IEEE 802.3 Maintenance

July 21st, 2005
San Francisco, CA

Activities this week

1168 - Comparison of requirements

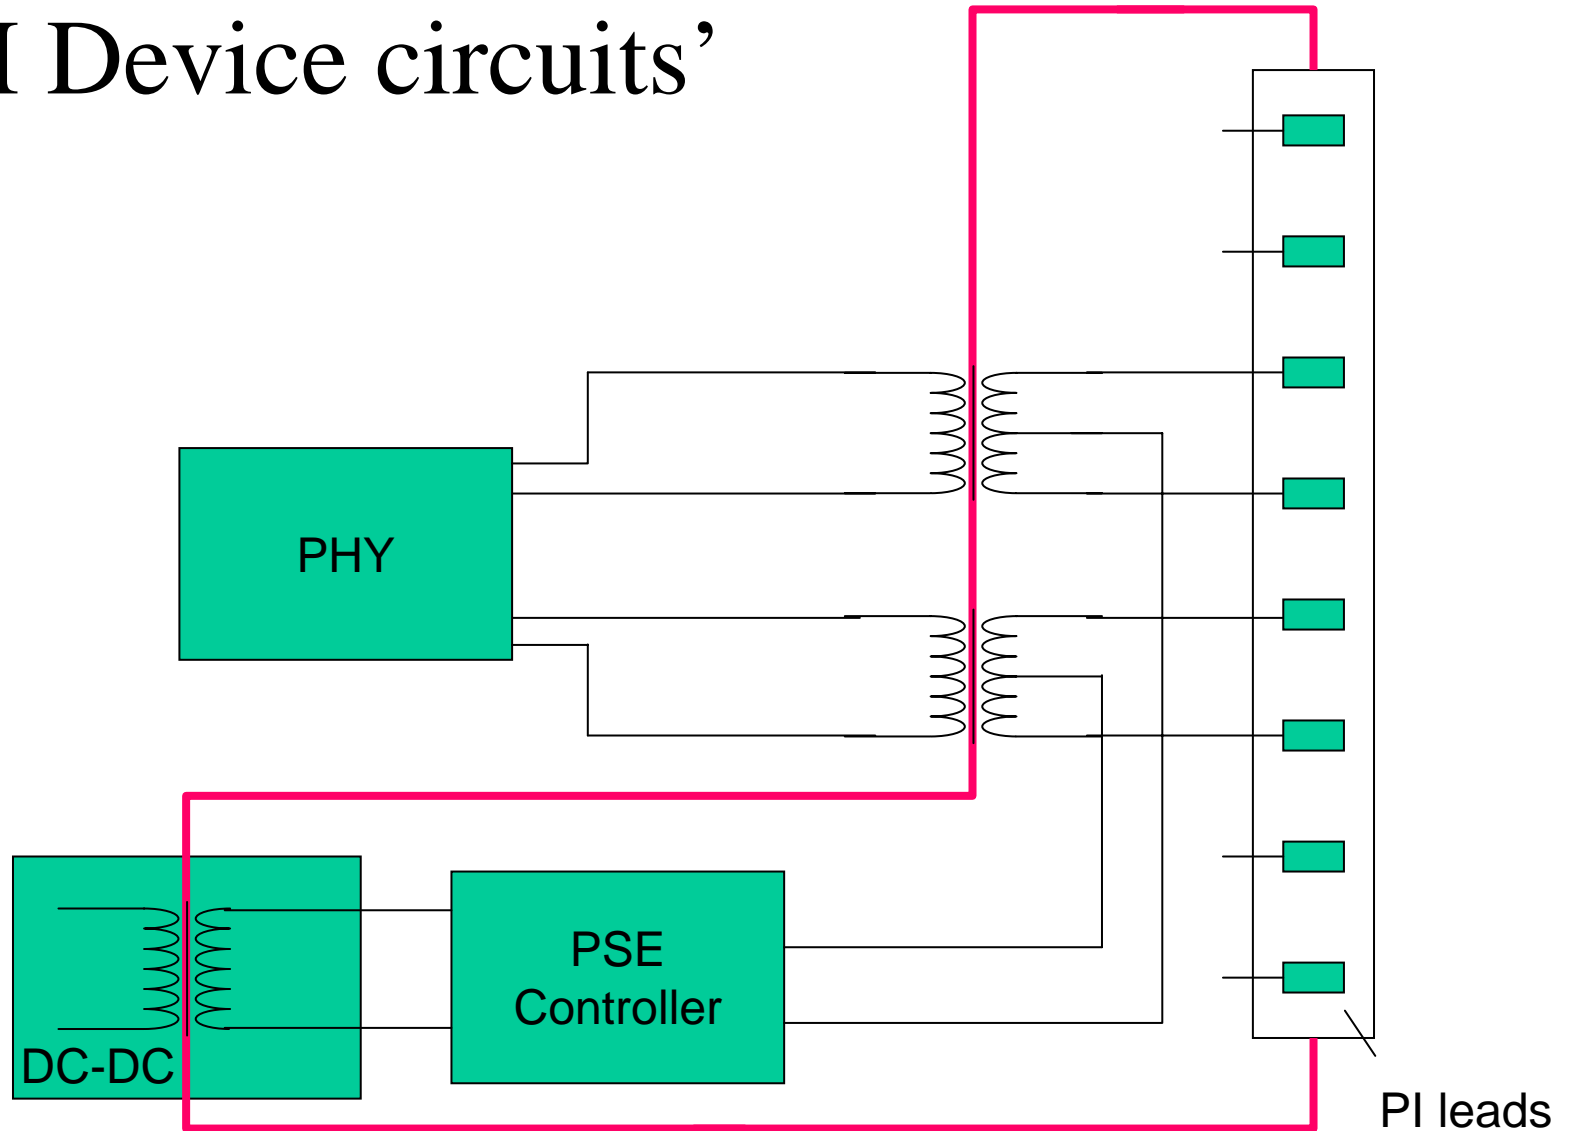
Isolation from all MDI leads to	AC and DC test			Impulse test	
		Vrms	Vdc	Test method	Impulse	Defined
10BASE-T	Frame ground and PHY device circuits	1500V	2250V	5.3.2 of IEC 60950:1991	2400V 1.2/50 us	IEC 60060
10BASE-T The PI of a PD within its MDI	Frame ground and all external conductors					
100BASE-T ^{Note1}	Frame ground	1500V	2250V	5.3.2 of IEC 950:1991	2400V 1.2/50 us	IEC 60
1000BASE-T	Frame ground and PHY device circuits	1500V	2250V	5.3.2 of IEC 60950:1991	2400V 1.2/5 us	IEC 60060
1000BASE-T The PI of a PD within its MDI	Frame ground and all external conductors					
DTE Power via MDI	PI Device circuits	1500V	Not allowed	6.2 of IEC 60950-1:2001	1500V 10/700 us	6.2.2.3 of IEC 60950-1:2001

Note 1 - see FDDI TP-PMD standard, ANSI X3.263: 1995 (TP-PMD).

'PI Device circuits'
